Environment, Transportation & Public Safety Standing Committee Sitting as the Transit Windsor Board of Directors

Item 9.2 - Written Submission

Comprehensive Community Concerns Report on Proposed Bus Route: Safety, Environmental, and Quality of Life Impacts on Radcliff Ave

Prepared by Mark Sementilli Resident of Radcliff Ave June 20, 2024 Please accept the following report on behalf of my neighbors and myself to express our collective concerns regarding the proposed new bus route through our neighborhood. Our extensive outreach efforts have revealed a significant level of opposition to this change, and I would like to provide a comprehensive overview of the key issues we have identified.

Lane Widths

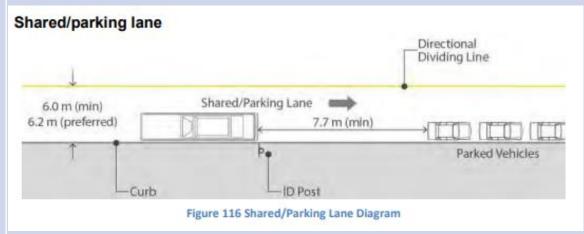
Findings	Continued	Continued		
Concerns	require busses to move in Furthermore, busses trav	Radcliff Ave does not meet the recommended lane widths and will require busses to move into oncoming traffic to avoid parked vehicles. Furthermore, busses traveling in the lane that does not have shared parking will have vehicles moving into that lane to avoid parked cars.		
Findings	Radcliff <u>does not meet</u> the Transit Windsor Design Guidelines with a direct impact to driver and public safety.			
	Minimum Maximum			
	3.3 meters	3.7 meters	Non parking lane	
riteria	6.0 meters 6.2 meters Shared parking lane			
	9.3 meters (30.5 ft)	9.9 meters (32.5 ft)	Total width

Too Narrow

Figure 1 Far-Side, Near-Side and Mid-Block Configurations

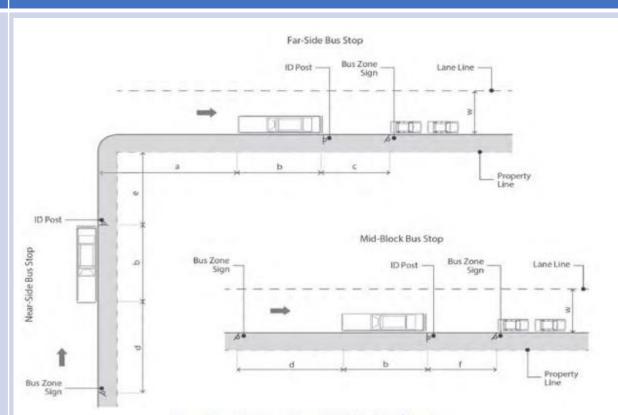
Each stop measured met the spacing requirements (minimizing the elimination of parking where the stops are) but they are **not compliant** for road width by a range of **1.7 meters to 2.7 meters (5.75-8.75 ft)**.

This supports residents concerns that buses will be required to move into oncoming traffic due to the narrowness of the road.

The proposed bus stop has been placed right at the cross walk/park entrance which is **not compliant** to the Design Standard.

Bus Stop Access Between Driveways

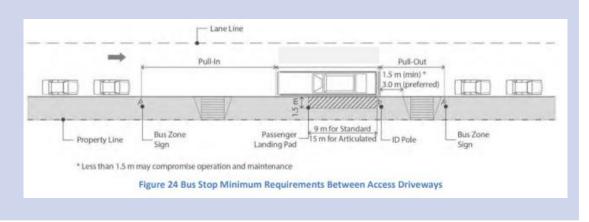
Sightlines and proximity to driveways is problematic at the east and west stops by Radcliff Ave and Savanna St.

Figure 112 Diagram of Bus Turning Right at an Intersection; TRANSIT WINDSOR ROUTE INFRASTRUCTURE PLANNING AND DESIGN GUIDELINES

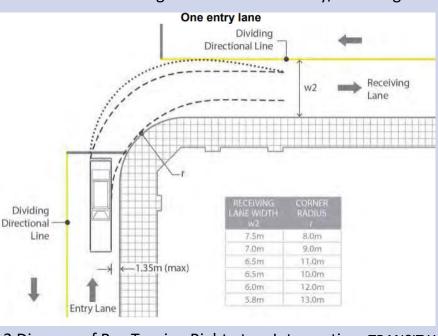
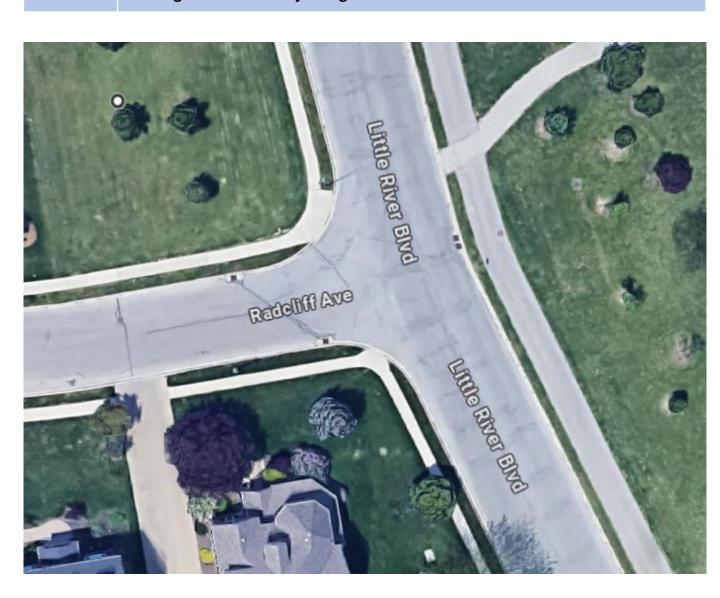
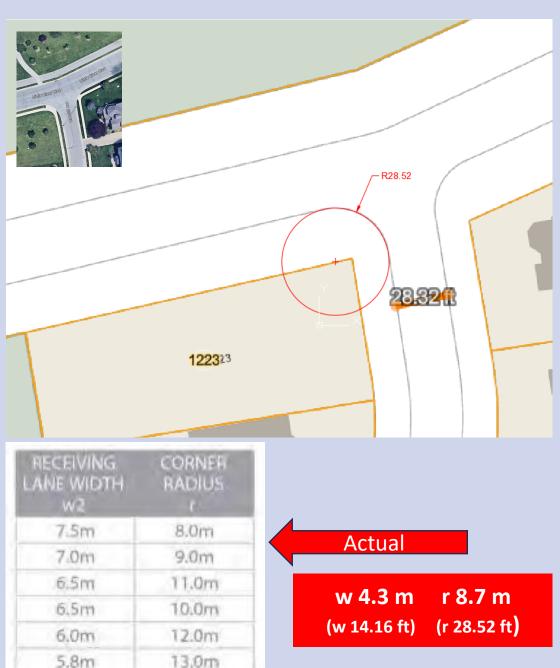
- Residents are concerns with the tight turn radii on and off Radcliff Ave at both Little River and McNorton St.
- Winding turns (reason for previous petition) at Radcliff Ave and Little River.
- Narrow street not wide enough accommodate bus traffic.
- Busses will create visibility issues with oncoming vehicles or vehicles turning to and from adjoining streets.

- Residents are concerns with the tight turn radii on and off Radcliff Ave at both Little River and McNorton St.
- Winding turns (reason for previous petition) at Radcliff Ave and Little River.
- Narrow street not wide enough accommodate bus traffic.
- Busses will create visibility issues with oncoming vehicles or vehicles turning to and from adjoining streets.

As per section 6 of the Transit Windsor Design Guidelines, Radcliff Ave needs to have a receiving lane of 7 meters and is currently 4.3 meters. Busses turning from Little River onto Radcliff Ave must do so with too tight a turn radius and is not compliant to the design criteria.

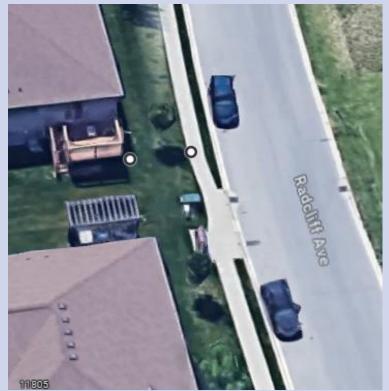
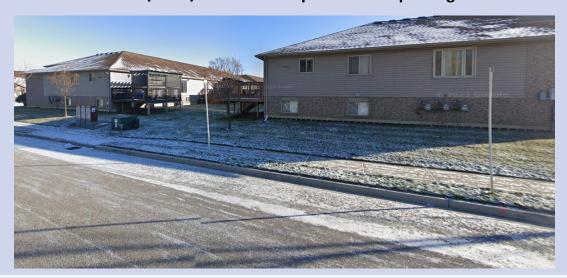
15 feet from house/deck/etc. to bus stop and loss of parking

No plans provided for Noise, Privacy or Vibration Abatement.

Condominium company requires access from Radcliff to maintain yards.
